## REMARKS

This application has been reviewed in light of the Office Action dated March 26, 2004. Claims 1-11 and 15-18 are presented for examination. Claims 12-14 have been canceled, without prejudice or disclaimer of subject matter. Claims 1-11 and 15-18 have been amended to define more clearly what Applicant regards as his invention. Claims 1, 7, 10, 11, 15, and 17 are in independent form. Favorable reconsideration is requested. The claims canceled herein will not be discussed further.

Appln. No. 09/400,549  
Admend. Dated 08/26/04  
Reply to Office Action of 03/26/04  
Annotated Sheet

FIG. 1 PRIOR ART

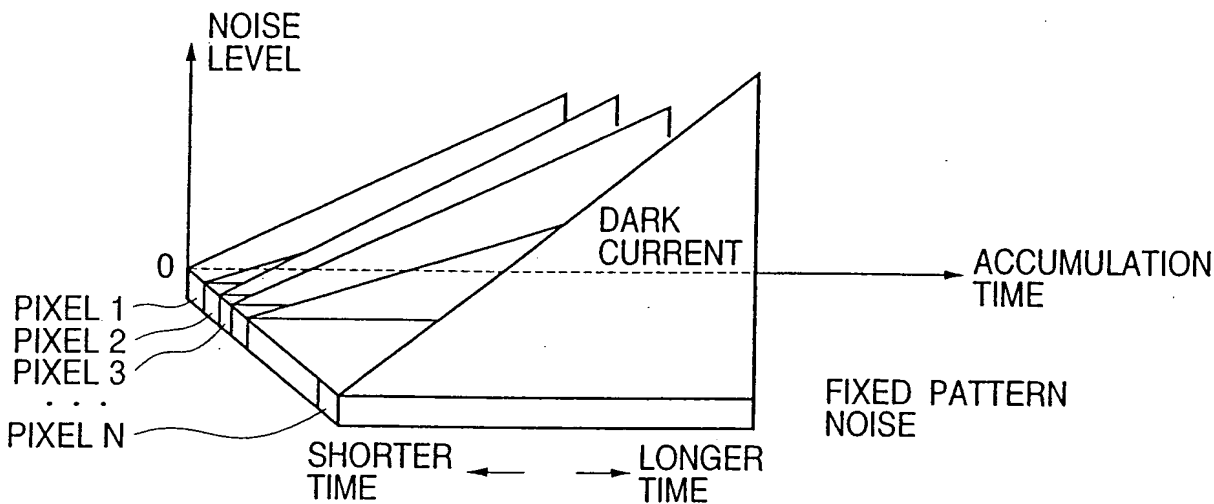
Figures 1, 2, 3, and 7A-C have been labeled "Prior Art".

FIG. 6A

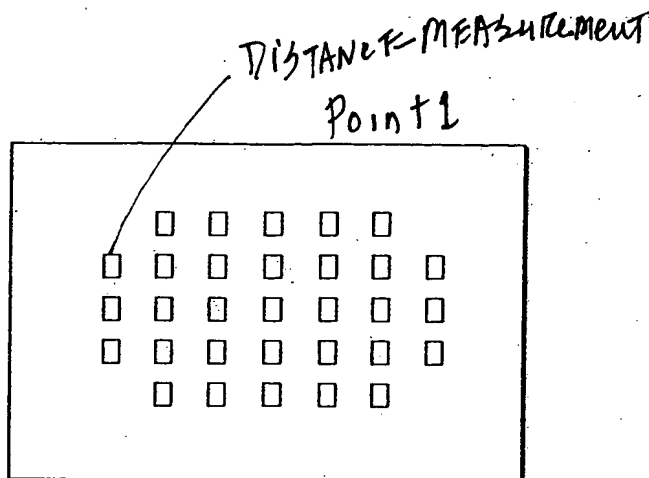
As to the term "distance measurement point 1" at page 21, line 6 of the specification, Applicant has amended Figure 6A to identify this element. Applicant also has the following comments regarding this element. The distance measurement point 1 recited at page 21, line 6, is one of a number of distance measurement areas described at page 11, line 12, of the specification, and thus is clearly shown in Figure 6A.<sup>1</sup> Support for this element may also be found at least at page 11, line 9, to page 12, line 2, and from page 20, line 18, to page 21, line 23.

In Figure 6A, Applicant has amended this figure to identify a "Distance Measurement Point 1".

FIG. 7B

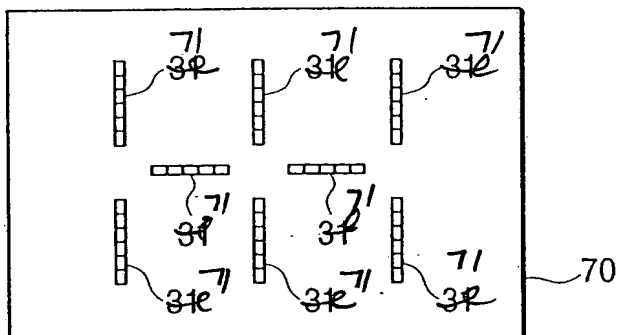
Figure 7B has also been amended to change reference designator "31" to read --71--, so as to be consistent with the specification.

FIG. 8

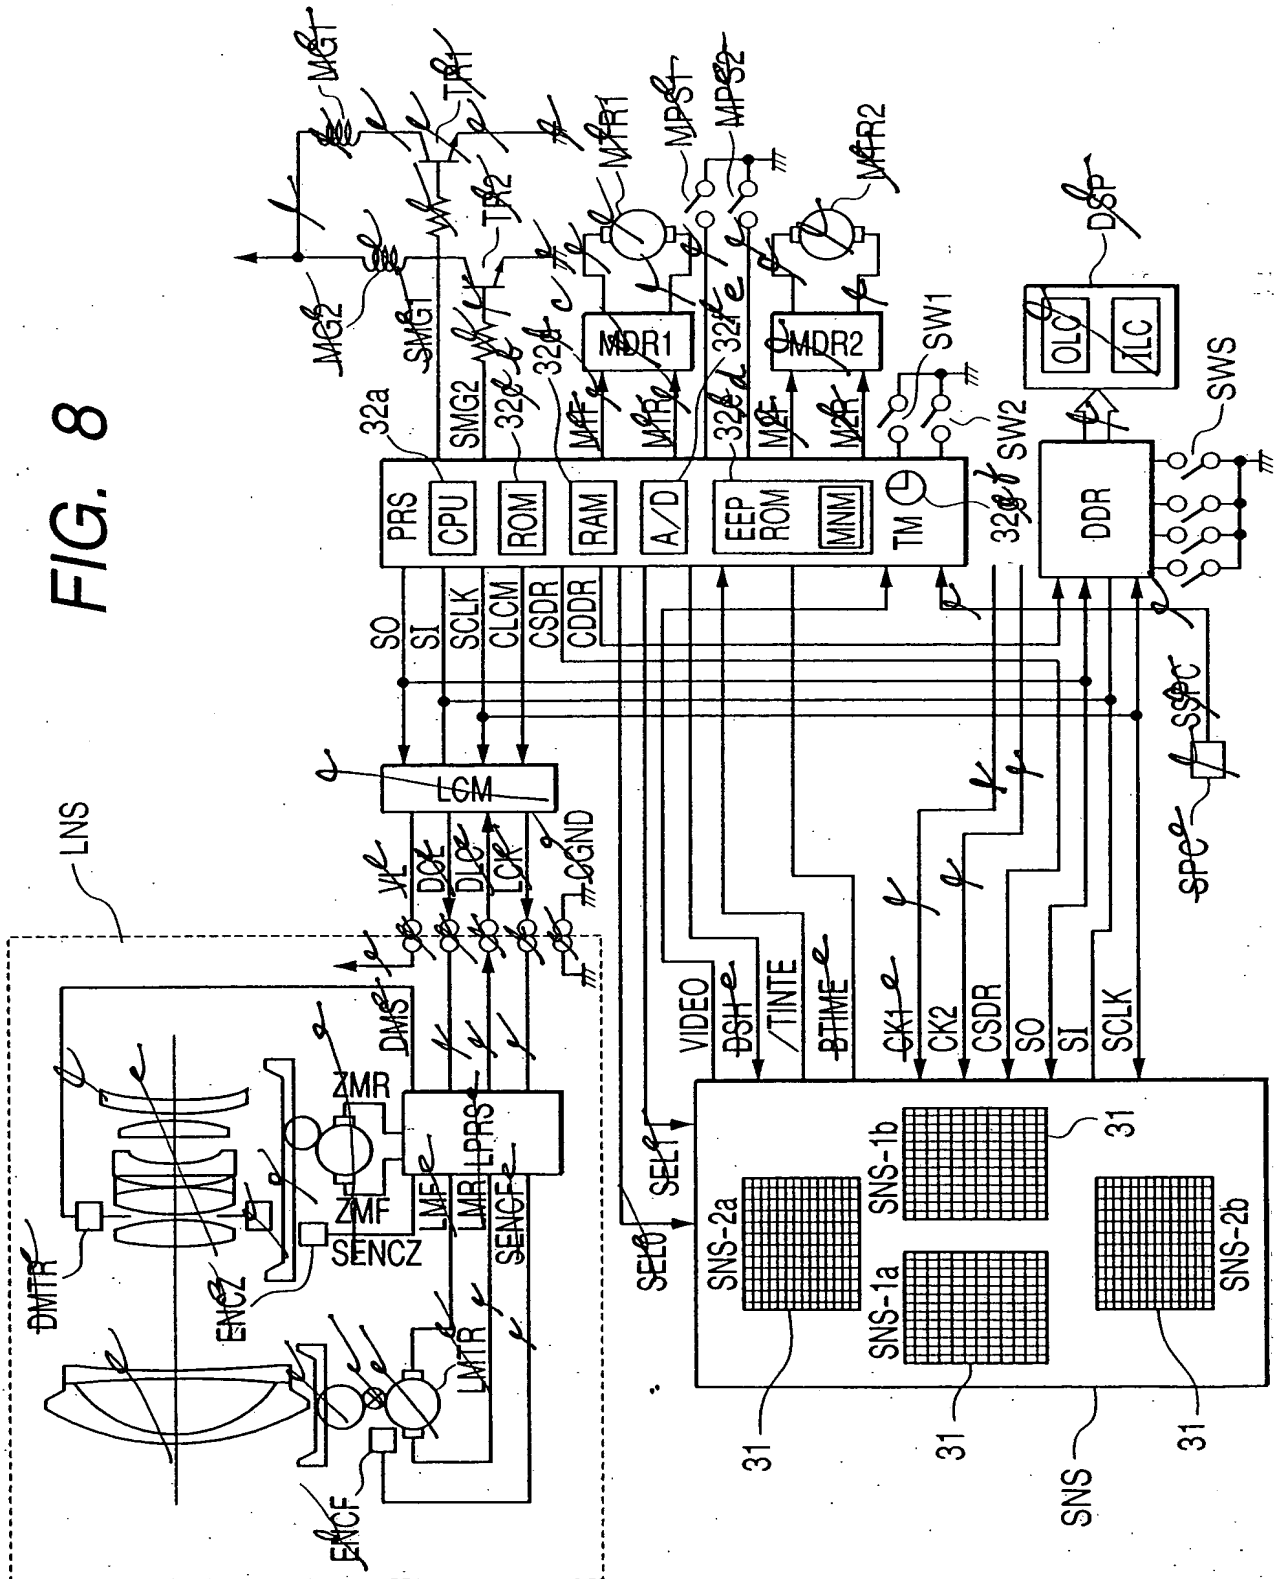
Figure 8 has been amended to delete the following reference designators (and symbols) DMTR, ENCZ, ENCF, SENCZ, ZMF, ZMR, LMTR, DMS, LMF, LMR, SENC, LPRS, VL, DCL, DLC, LCK, CGND, LCM, MG2, MG1, SMG1, TR1, SMG2, TR2, MTR1, M1F, M1R, MDR1, MPS1, MPS2, MDR2, M2F, M2R, MTR2, OLC, ILC, DSP, SSPC, SPC, SEL0, SEL1, DSH, BTIME, CK1, and CK2. Figure 8 has also been amended to change reference designators "32c, 32d, 32e, 32f, and 32g", to read --32b, 32c, 32d, 32e, and 32f--, respectively.
